11 December 2025

Our Reference: 24-0484C

Re: Julius Avenue Data Storage Centre—ACHAR addendum

Figure 2 Plan of the proposed design amendments. The black dashed line indicates the previously approved DA outline, and the blue dashed line shows the previous STSS footprint. (Source: Greenbox, 2025)

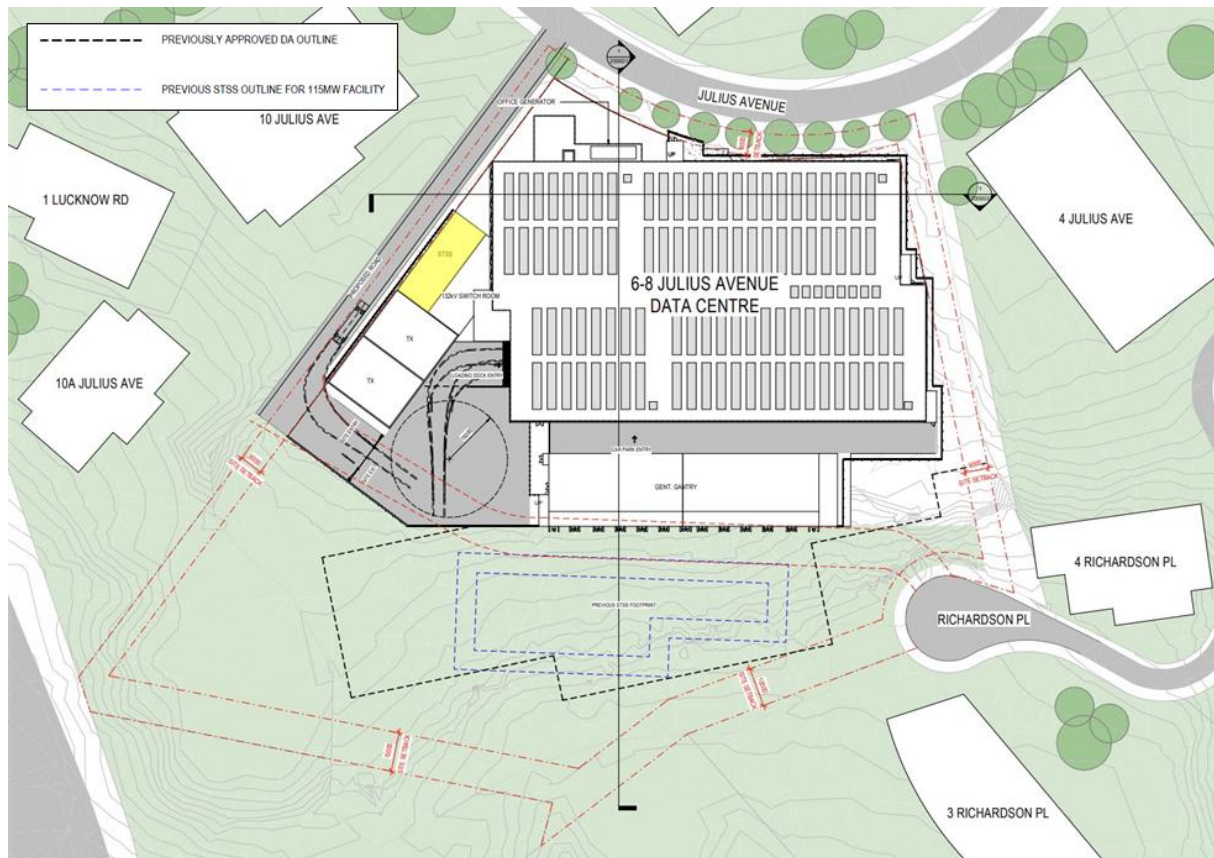
Based on agency and stakeholder feedback, Logic Project Co propose to amend the project design and impact footprint. The overall data centre facility IT load has been reduced, in turn resulting in design modifications including the removal of basement levels, reduction in size of the Sub-Transmission Switching Station (STSS), and removal of the proposed link road within the south of the study area (Figure 2 and Figure 3).

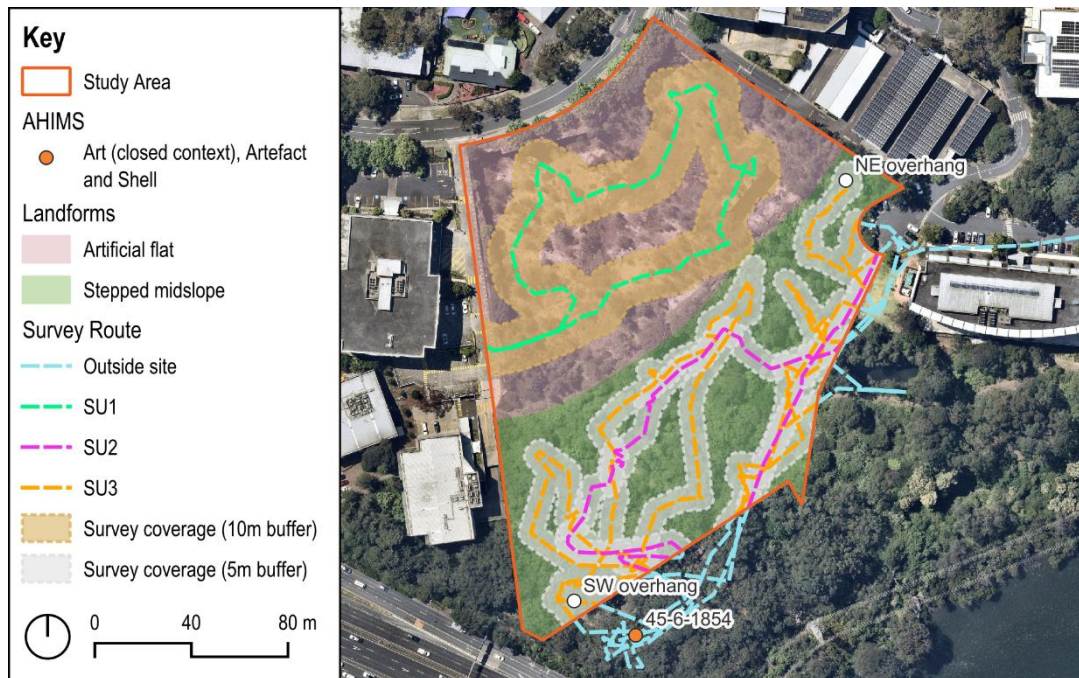
The STSS facility will be moved out of the bushland portion of the study area in the south and into the previous disturbed north of the study area, along the western side of the proposed data centre building. This reduces impacts to the bushland within the south of the study area by 3,246m². Combined with the removal of the link road under the proposed design amendments, the majority of the southern bushland portion of the study area will not be subject to development impacts, with the aim of retaining the native vegetation within this area.

Figure 4 Survey coverage across SUs 1, 2 and 3 from the March and December 2025 archaeological surveys. (Source: Nearmap with GML overlay, 2025)

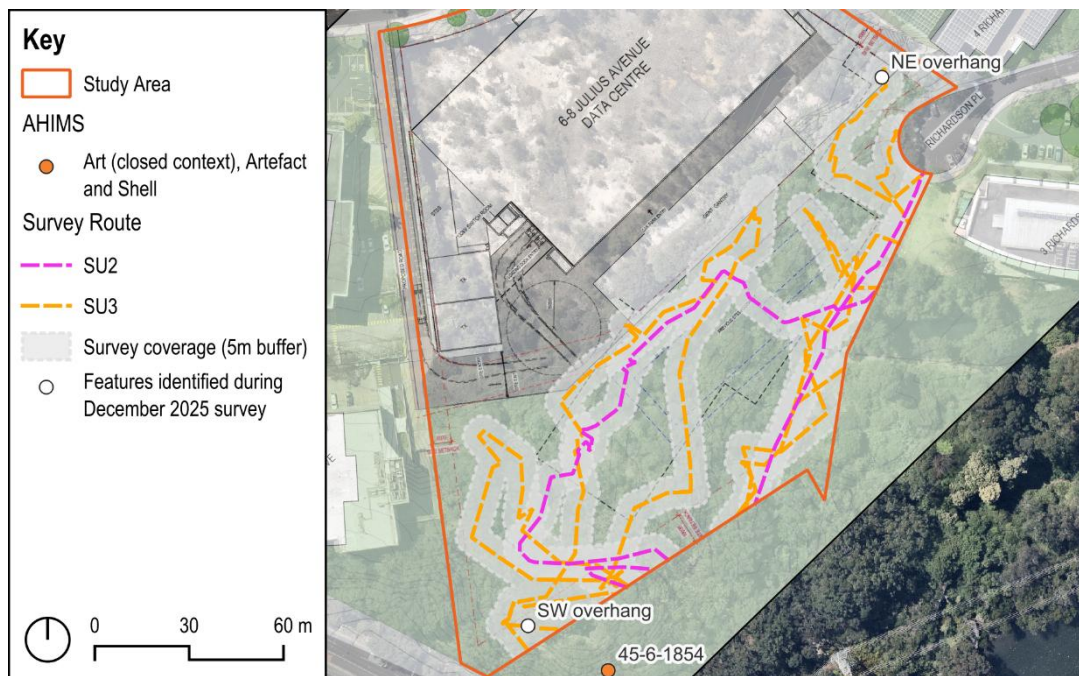
1. *The survey coverage indicated in Figure 4.1 does not sufficiently sample the area of proposed works in Survey Unit 2 (SU2). Heritage NSW note that as indicated in Section 4.1, SU2 has the potential to contain sandstone outcrops and overhangs which may contain Aboriginal objects/art/engravings. In consideration of this;*
 - a. *Additional survey is required in SU2 where works are proposed, specifically the access road connection to Richardson Place and the location of the Ausgrid STTS [sic] and Indoor MBS Room. Please update the ACHAR with additional survey tracks and discussion of the results of the additional survey.*

Previous archaeological survey undertaken for the ACHAR in March 2025 (see SU1 and SU2 in Figure 4) confirmed the extent of impacts within the northern portion of the study area and suggested that the southern portion of the study area, which comprised predominantly regrowth vegetation, had been subject to some prior disturbance. When coupled with the mid-slope landform context, the south portion of the site was considered to hold low Aboriginal archaeological potential. Areas of disturbance not noted in examination of aerial photography were observed within the south of the study area during the survey, including a semi-formal walking track, evidence of sub-surface services, low earth mounds understood to be soil stockpiles associated with past land clearing, and frequent crushed sandstone, interpreted as debris from land clearance works within this area in the mid-2000s and debris from upslope works washed or rolled downslope.

Additional survey was conducted as a single survey unit; Survey Unit 3 (SU3) (Figure 4 and Figure 5). Ground cover and visibility across Survey Unit 3 was moderate to low, with dense vegetation obscuring ground surfaces both on the flatter portions of the stepped midslope (Figure 6) as well as on the inclined portions (Figure 7).
